Local Planning Panel

Item 3.**Section 8.2 Review of Determination - 21 O'Connor Street, Chippendale - RD/2018/1360/A**

File No.: RD/2018/1360/A

Figure 8: Proposed ground floor plan

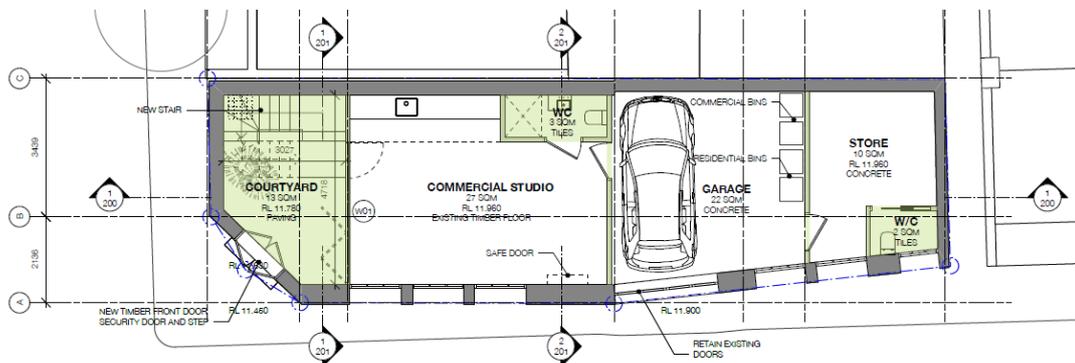
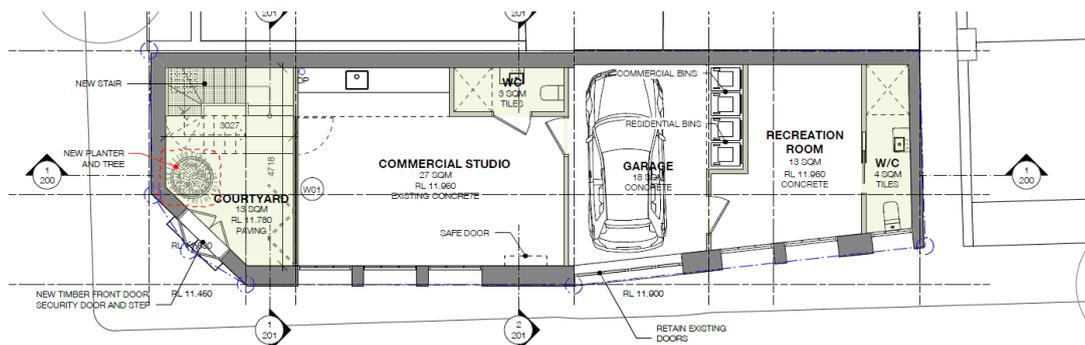
16. A comparison between the refused and proposed plans and elevations is shown in Figures 7 to 22 below.

Figure 23: Proposed west elevation with 9m height control shown in red and the height of the existing building shown dashed in blue.

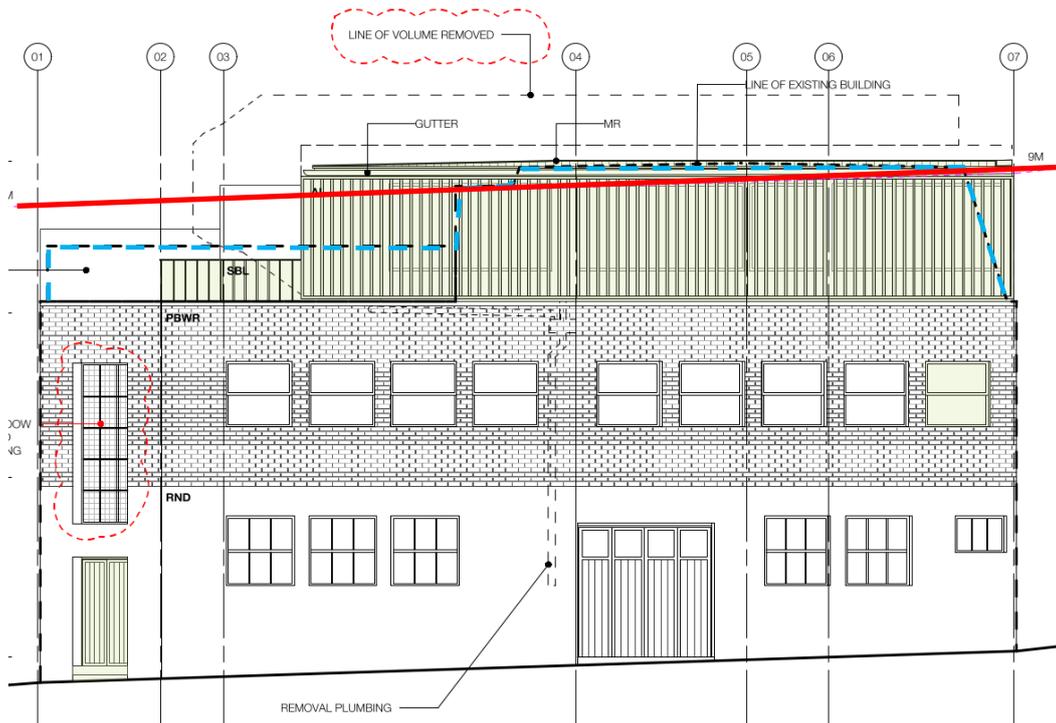
44. The site is subject to a maximum Height of Buildings control of 9m. The existing building has a height of 9.41m (RL21.18) and the proposed development has a maximum height of 9.56m (RL21.30).
45. The variation to the height control results in an exceedance of the development standard by 0.56m which equates to a 6.22% variation.

46. The red line in Figure 23 shows the 9m height control in context with the proposed development.

Figure 24: Existing and proposed GFA diagrams submitted by the applicant. The GFA is shown in red.

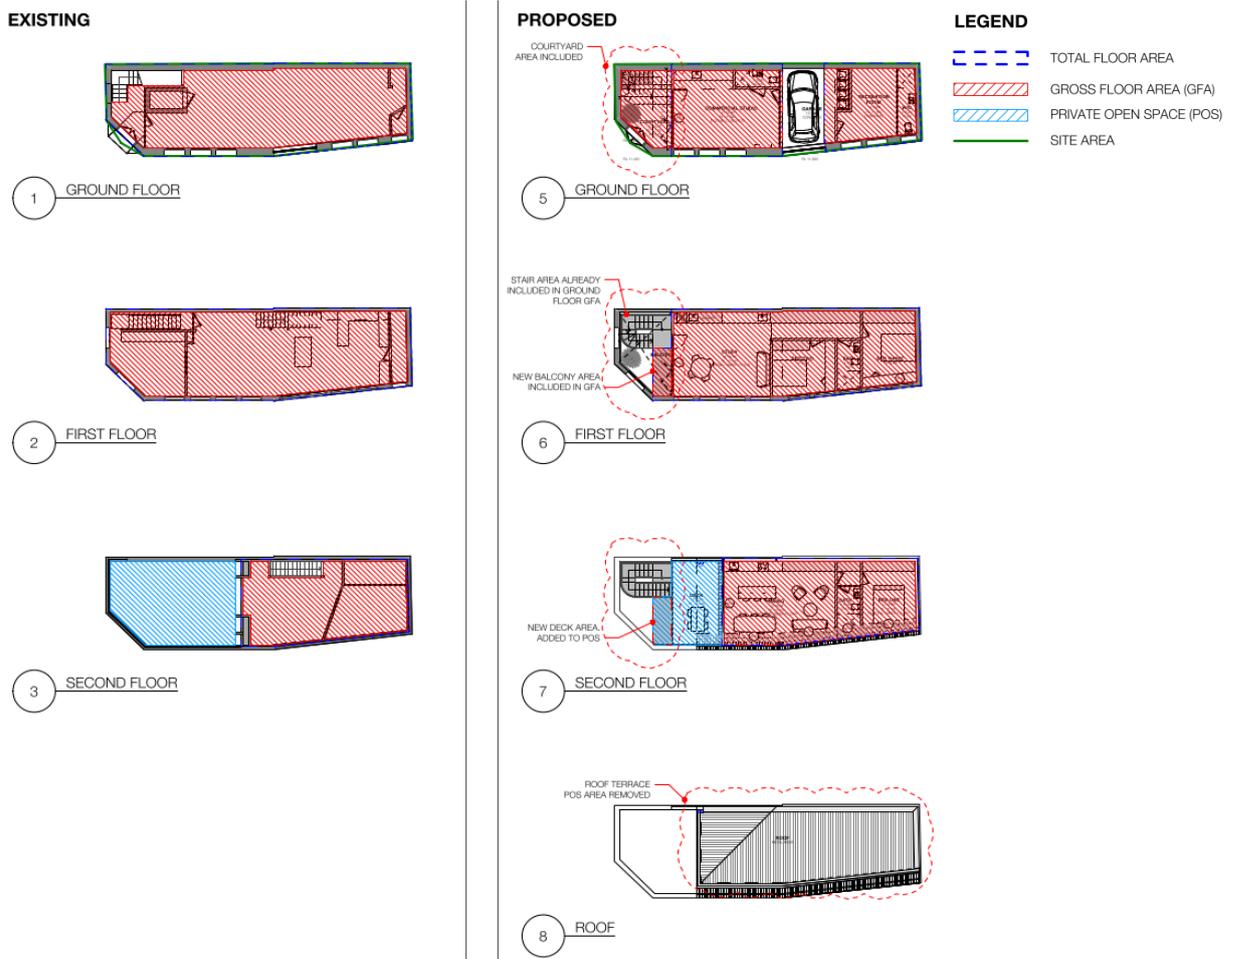
59. The site is subject to a maximum Floor Space Ratio (FSR) of 1.5:1. The proposed development has an FSR of 1.89:1.
60. The existing building has an FSR of 2.11:1. The proposal results in a net decrease of 14.59sqm of floor space due to the installation of a void at first and second floor levels and the provision of a car parking space at the ground floor level. Despite the reduction in floor space, the development still represents an exceedance of 0.39:1 which equates to a 26.3% variation to the FSR development standard.
61. Figure 24 shows the Gross Floor Area plans submitted by the applicant.

Figure 4: Proposed ground and first floor plans

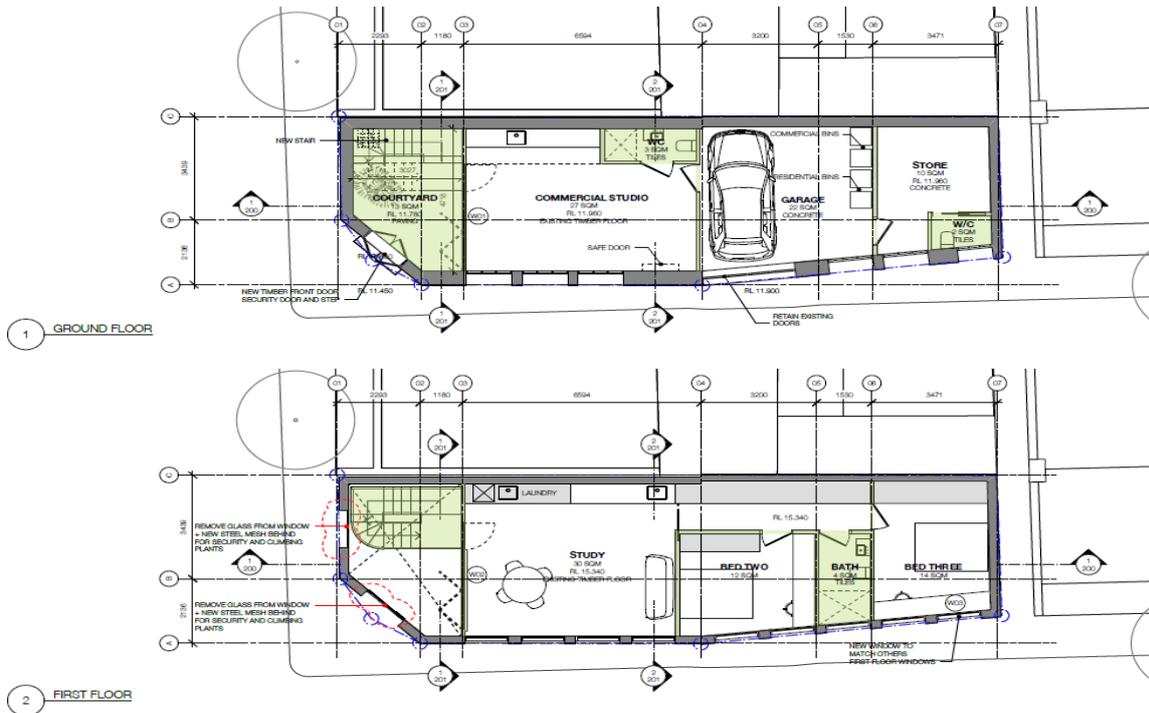
11. Amended plans were received on 23 January 2019 and form the basis of this assessment.
12. Plans of the proposed development (as amended) are provided below.

Figure 13: The applicant's FSR calculations showing existing FSR (left) and proposed FSR (right). FSR is shown in red and private open space in blue.

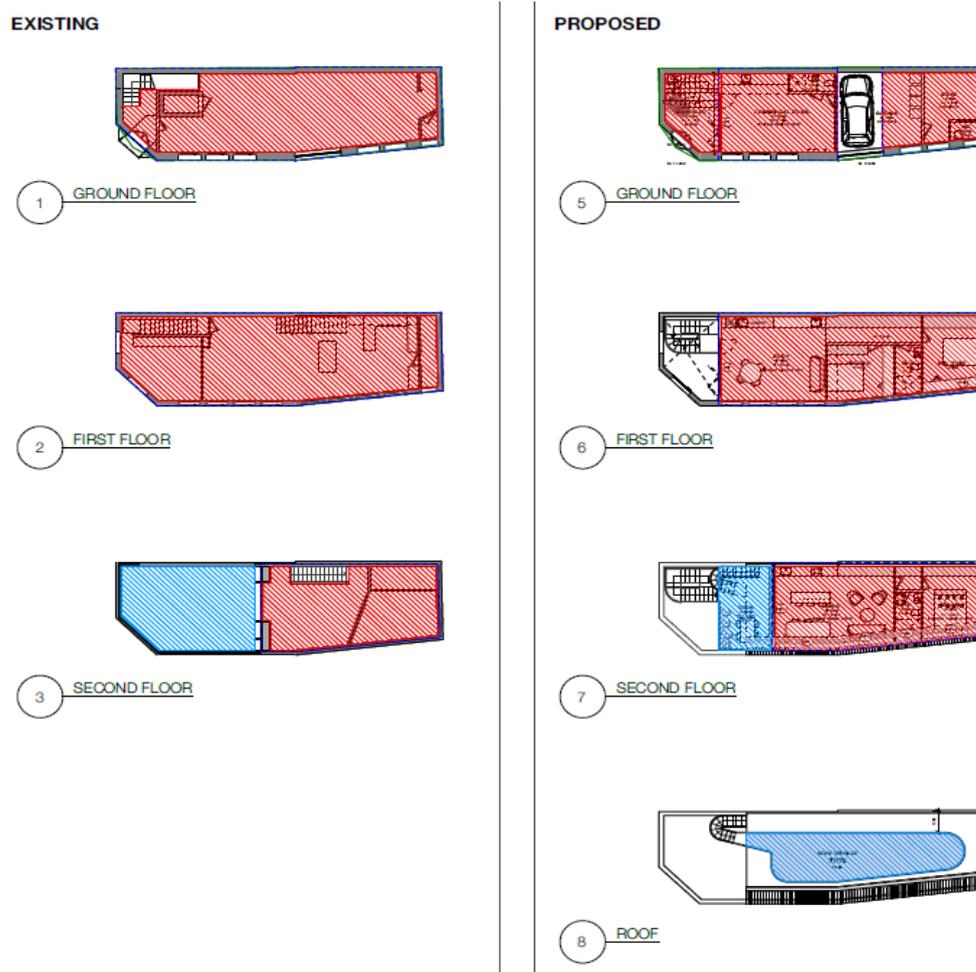
41. The site is subject to a floor space ratio control of 1.5:1. The proposed development has a floor space ratio of 1.93:1.
42. The existing building has an FSR of 2.11:1. The proposal results in a net decrease of 16.52sqm of floor space as a result of the creation of a void at the first and second floor and provision of a car parking space within the ground floor. Despite the reduction in floor space, the development still represents an exceedance of 0.43:1 (25% over the standard).

63. The roof terrace will result in an unacceptable privacy impact, and the external stair and balustrade create additional bulk and overshadowing. As illustrated in Figure 13, the roof terrace overlooks the private open space of several neighbouring properties.
